SAINT IGNATIUS PARISH SUBDIVISION, SECOND RESUBDIVISION OF

APPLICATION NUMBER 2 DATE June 20, 2019

REQUEST Subdivision

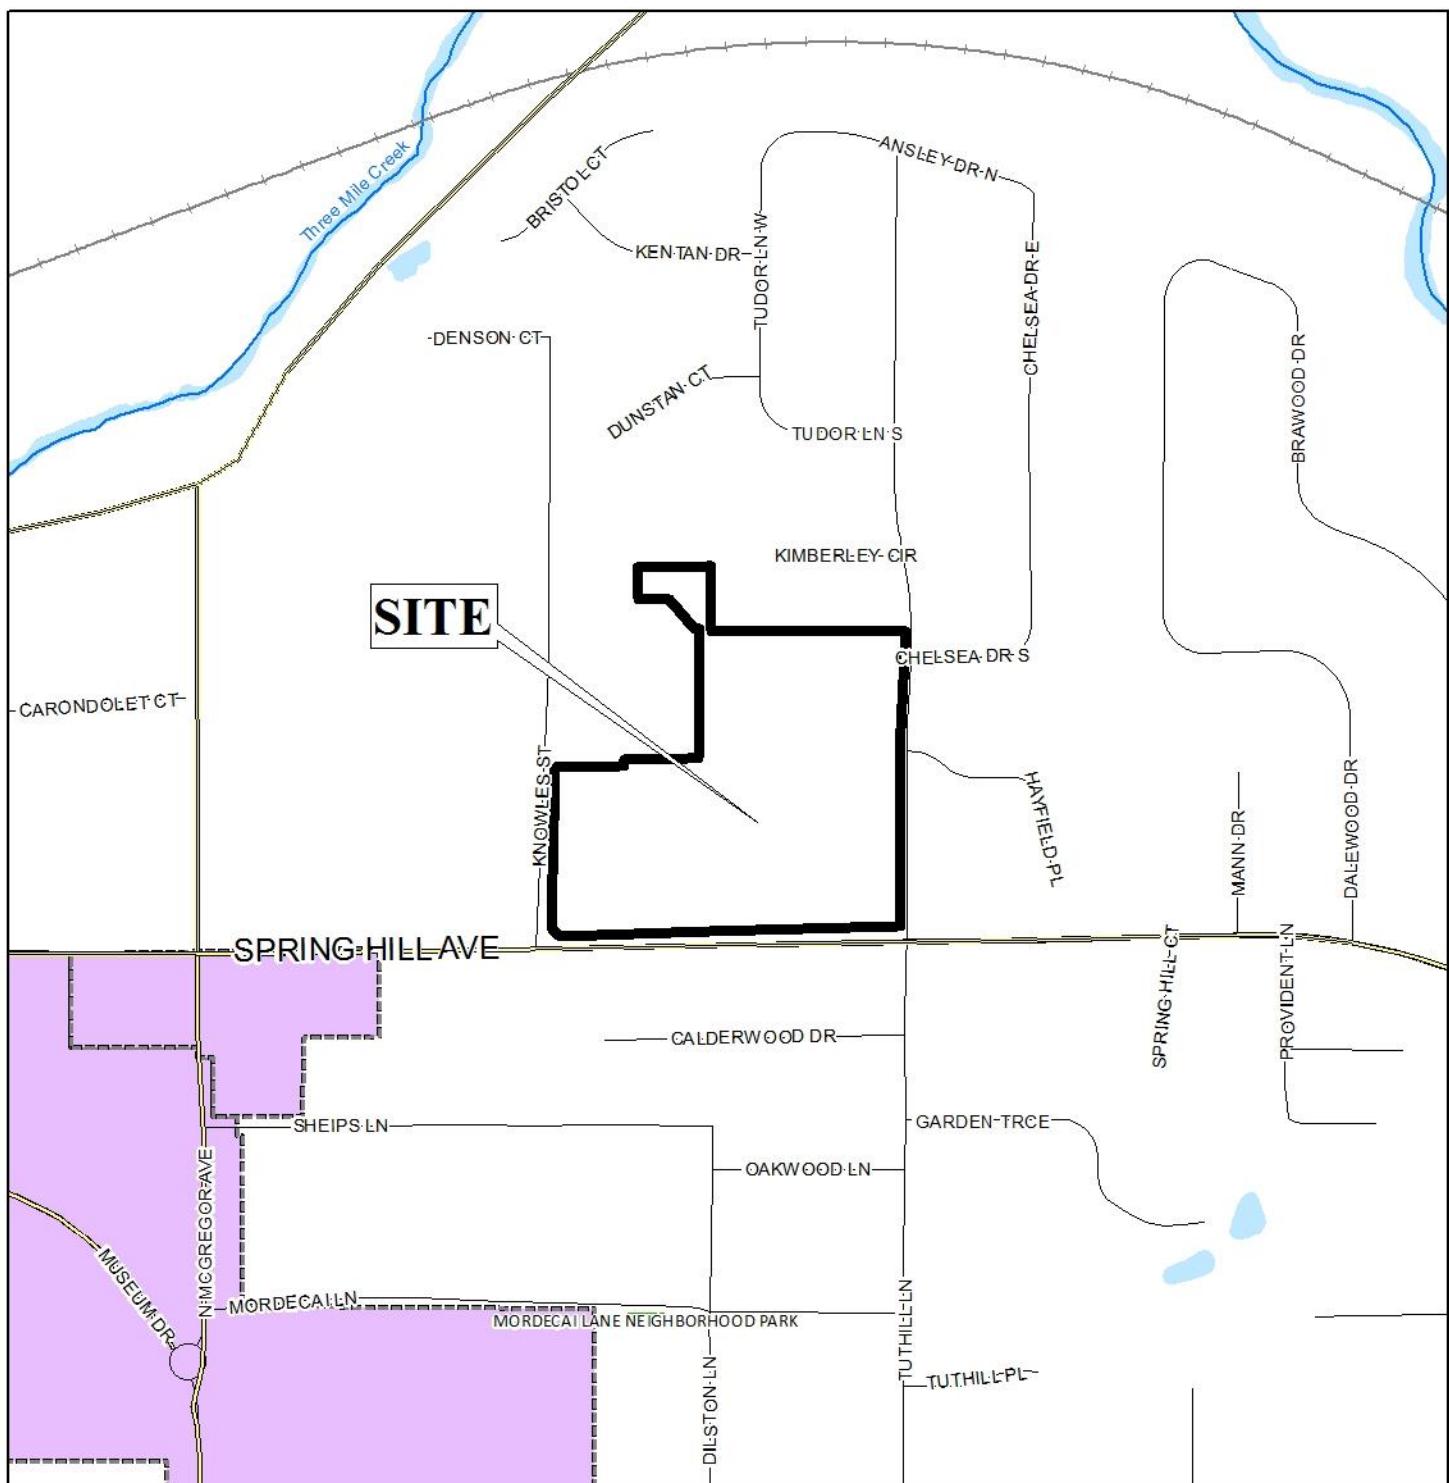
This Subdivision Application is being submitted to revise the minimum building setback requirement along Spring Hill Avenue from 25 feet to 20 feet to accommodate a new church building and to revise the minimum building setback requirement along Tuthill

Lane from 25 feet to 20 feet to accommodate a new administration building. These building setback modifications are in agreement with the latest approved PUD. No changes are being requested other than the building setback requirements.

As the Planning Commission approved the Planned Unit Development and Planning Approval with reduced building setbacks for the proposed church and administration buildings, it would follow that such reduced setbacks would be in order for this resubdivision. However, on the preliminary plat, those proposed reduced setbacks are illustrated to extend entirely along the Spring Hill Avenue and Tuthill Lane frontages. As the church and administration buildings are proposed to encroach within the normal 25' setback only in a small area along each street frontage, staff is of the opinion that the reduced setback allowance should only apply to those two areas and not the entire street frontages. Therefore the plat should be revised to block-out the 20' minimum building setback line along Spring Hill Avenue and Tuthill Lane to be within the area of the proposed church and administration buildings and retain the standard 25' setback beyond those block-outs.

- 1) revision of the plat to block-out the 20' minimum building setback line along Spring Hill Avenue and Tuthill Lane to be within the area of the proposed church and administration buildings and retain the standard 25' setback beyond those block-outs;

- 2) retention of the recorded property line setbacks along all boundaries and street frontages, except along Spring Hill Avenue and Tuthill Lane;
- 3) placement of a note on the Final Plat stating that no structure may be placed or constructed within any easements;

- 4) retention of the lot size label in both square feet and acres on the Final Plat, or the furnishing of a table on the Final Plat providing the same information;

- 5) placement of a note on the Final Plat stating that the site is limited to the Planned Unit Development and Planning Approval site plans approved by the Planning Commission at its February 21, 2019 meeting, or any subsequent approvals;
